Addendum No. 2
August 24, 2022

Project: **St. Mary Catholic School Addition & Remodel**
812 N. State Avenue
Dell Rapids, South Dakota 57022
Architecture Incorporated Project #2788

Scope of this Addendum:

FIRST FLOOR PLAN - AREA B - PLUMBING & HEATING
SCALE 0 4 8 12 16

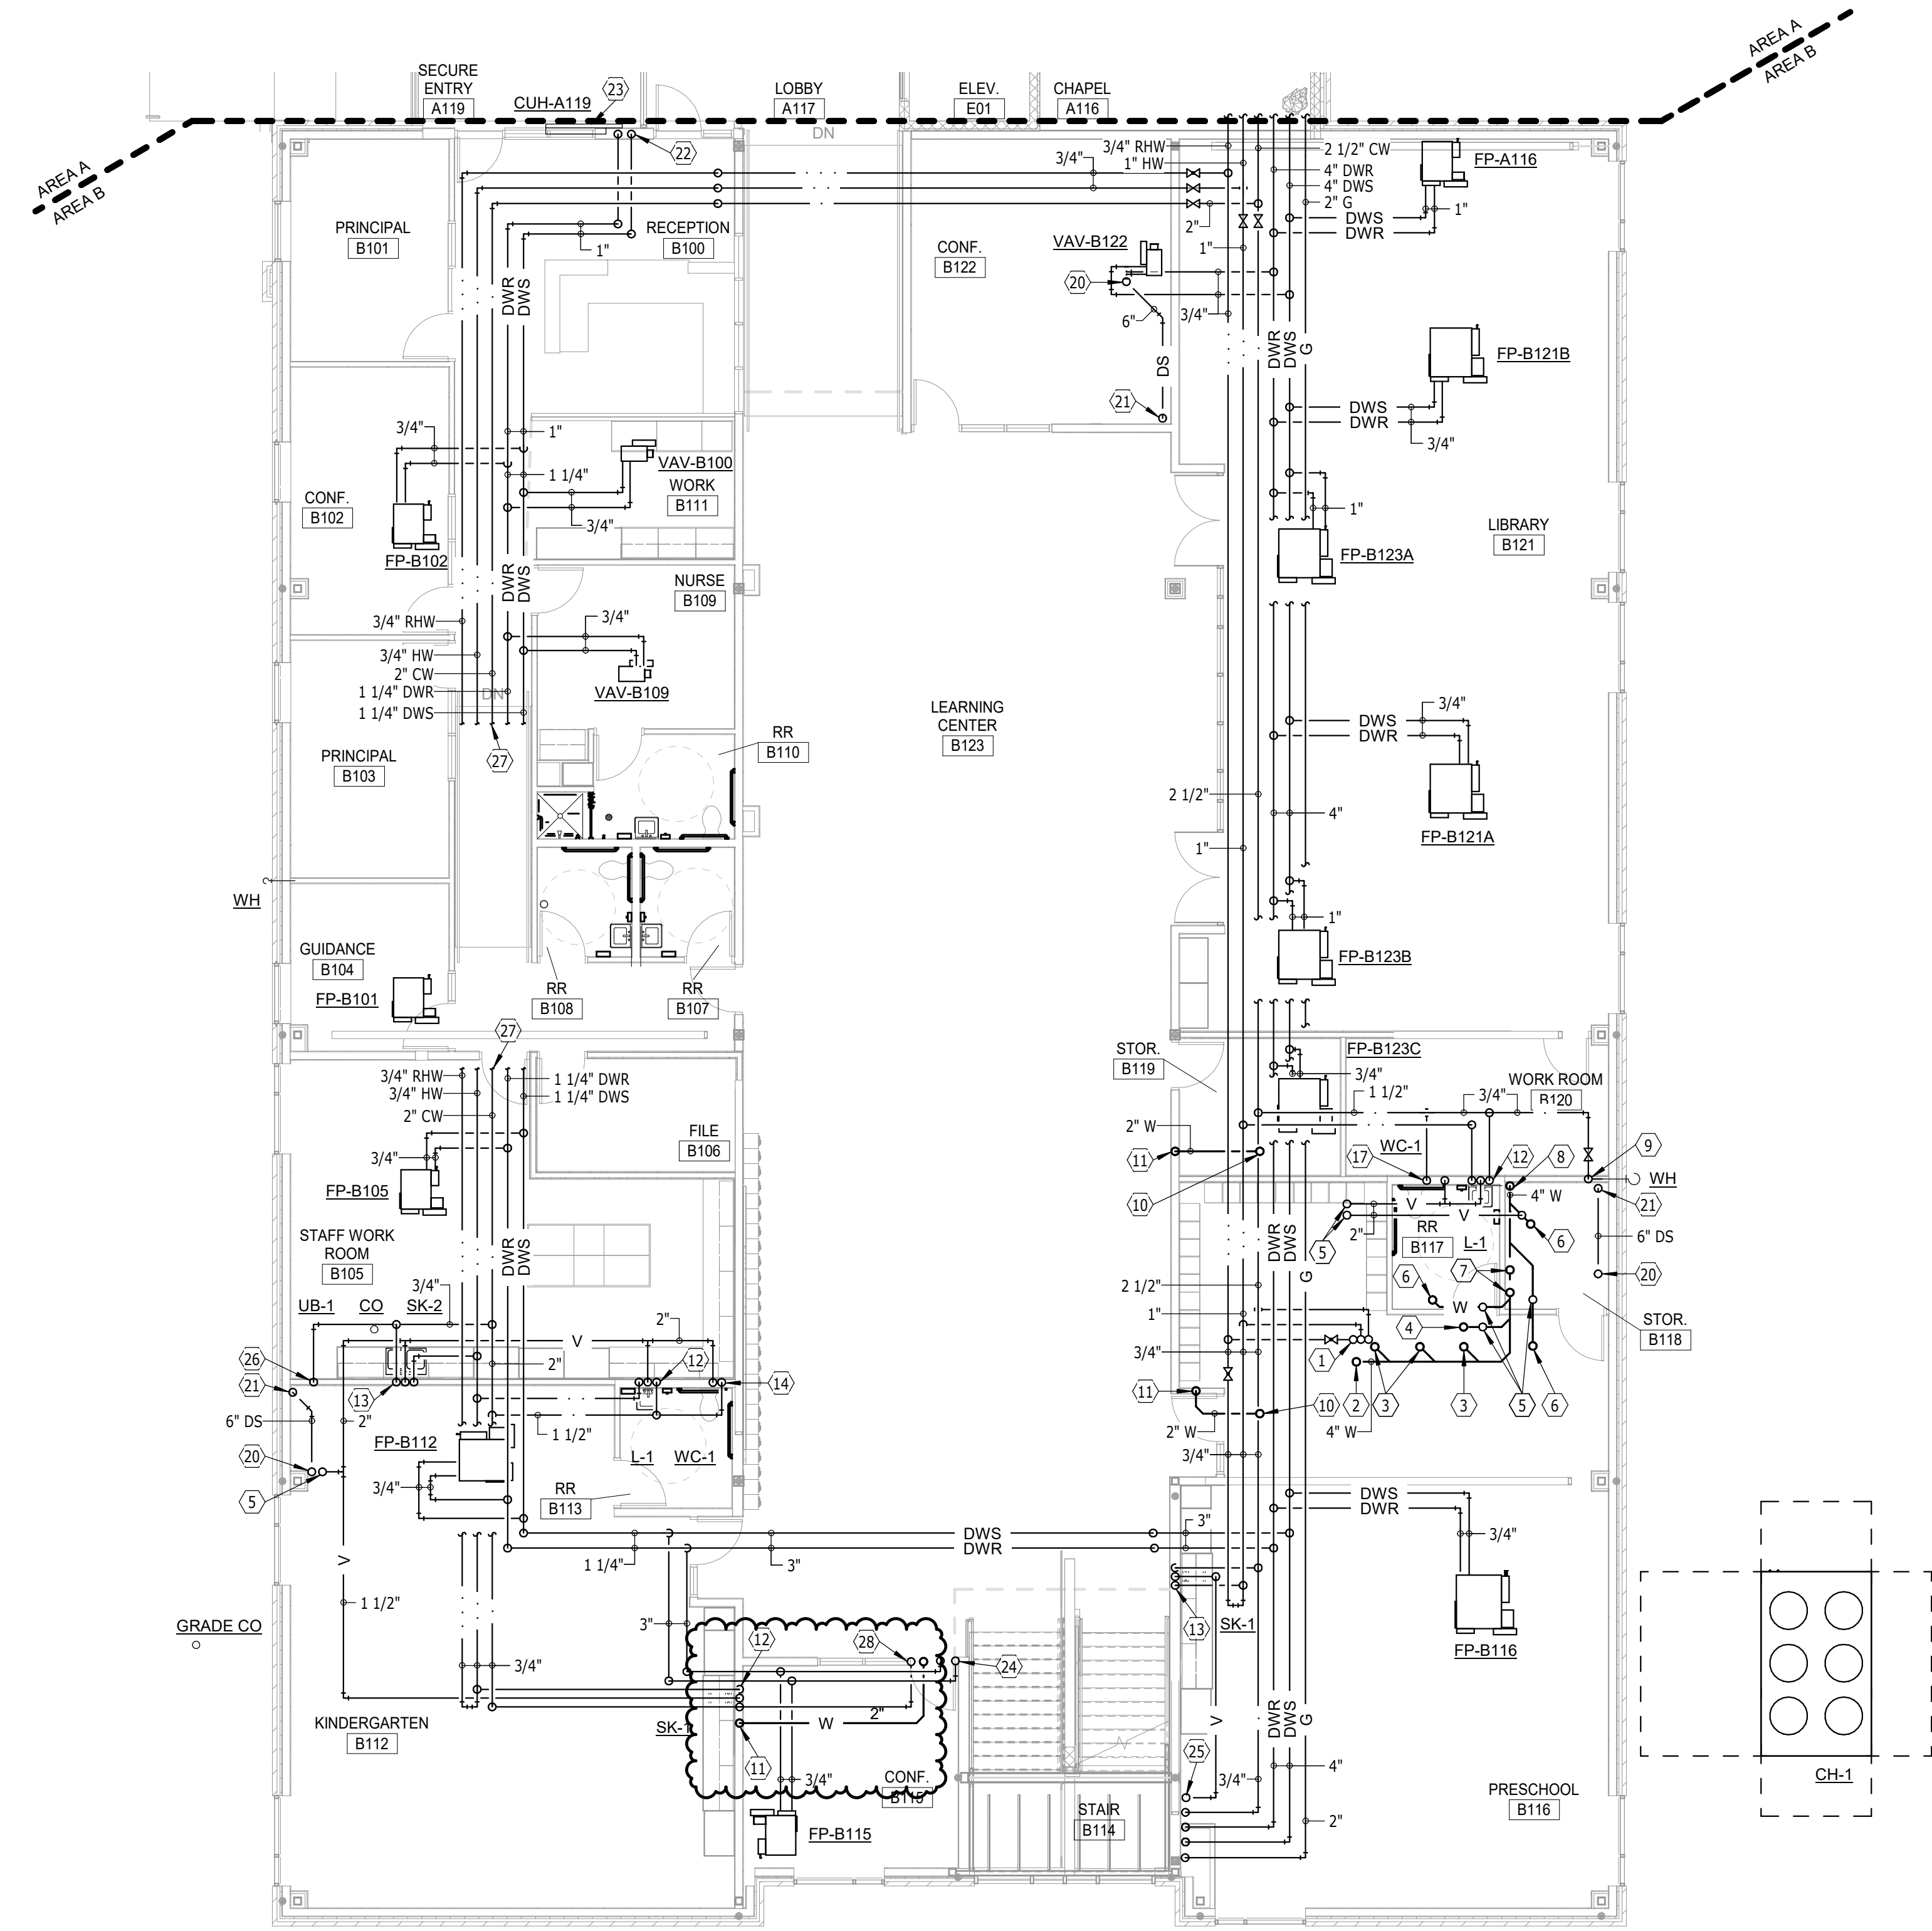
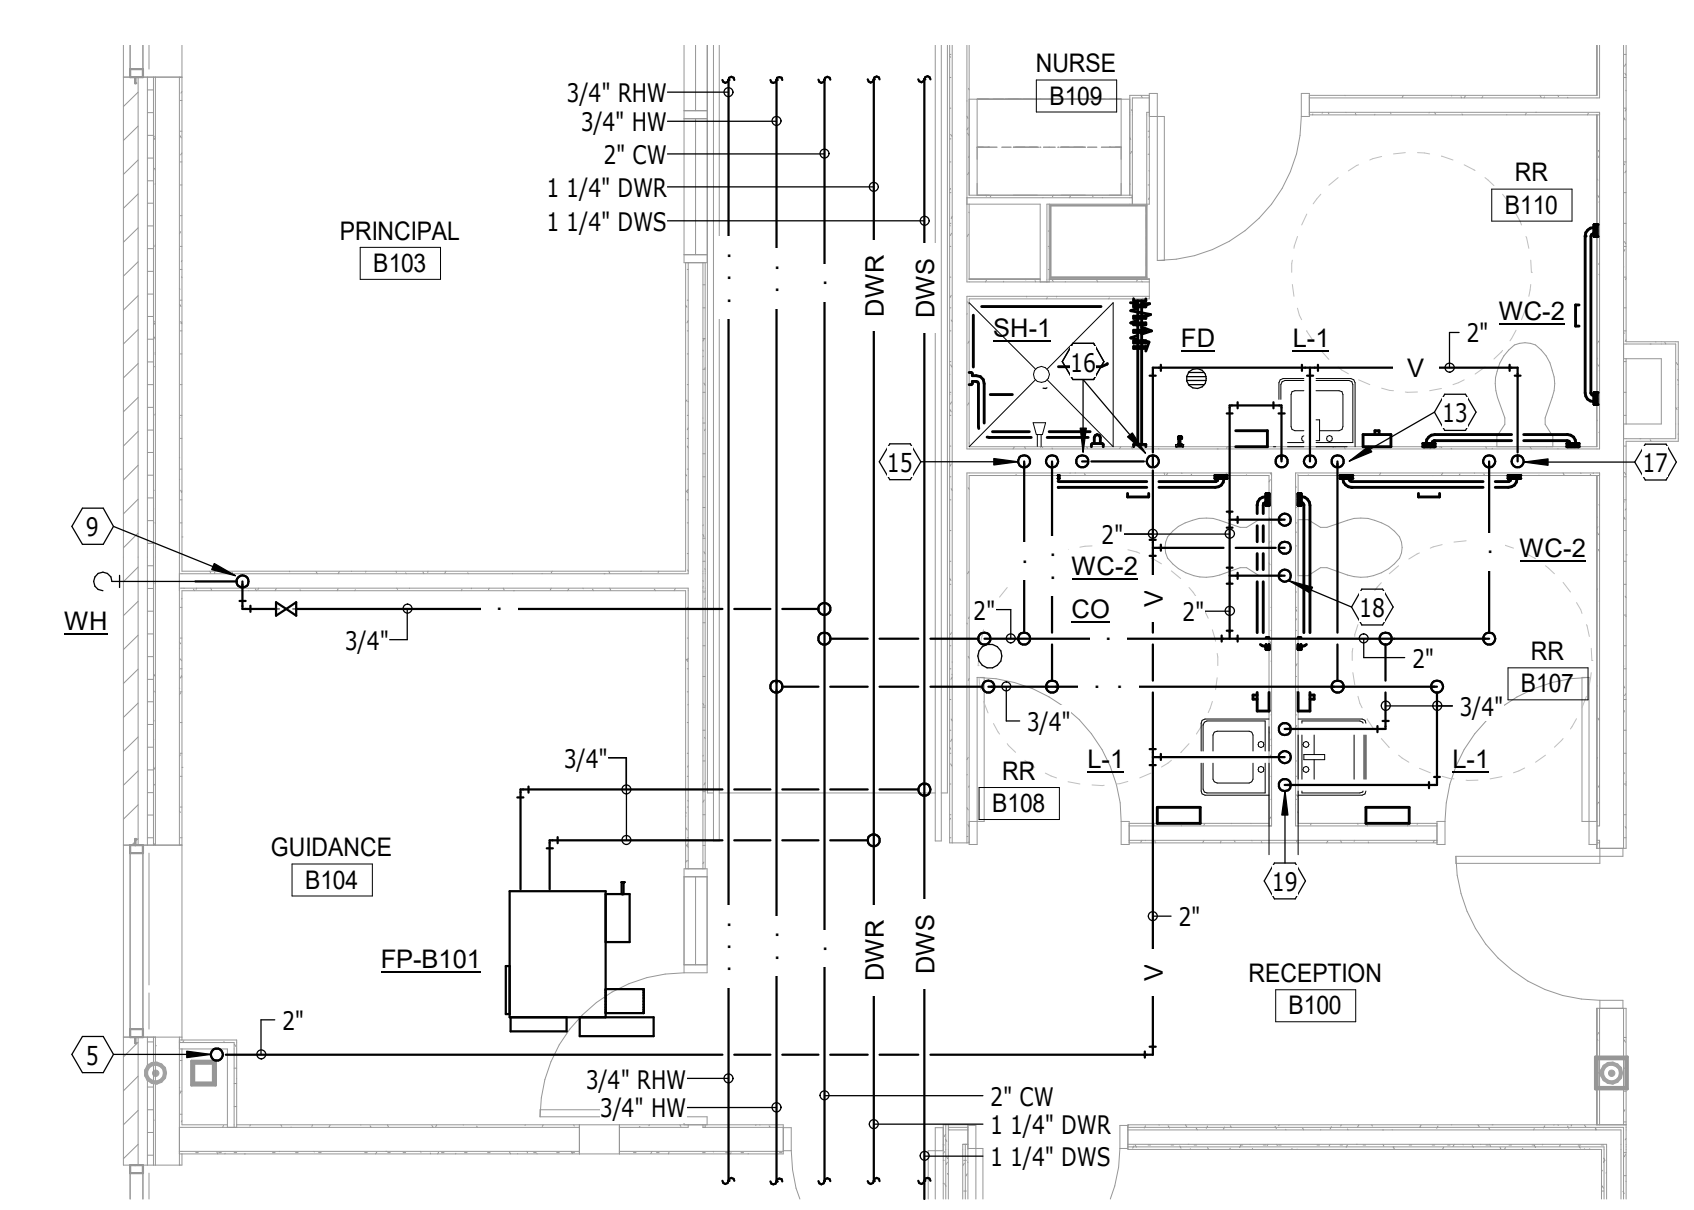
29. DRAWING SHEET 8.34 – FIRST FLOOR PLAN – AREA B – PLUMBING & HEATING
- a. Add electric water cooler & associated piping. See attached sheet.
30. DRAWING SHEET 8.35 – SECOND FLOOR PLAN – AREA A – ALTERNATE #5 – PLUMBING & HEATING
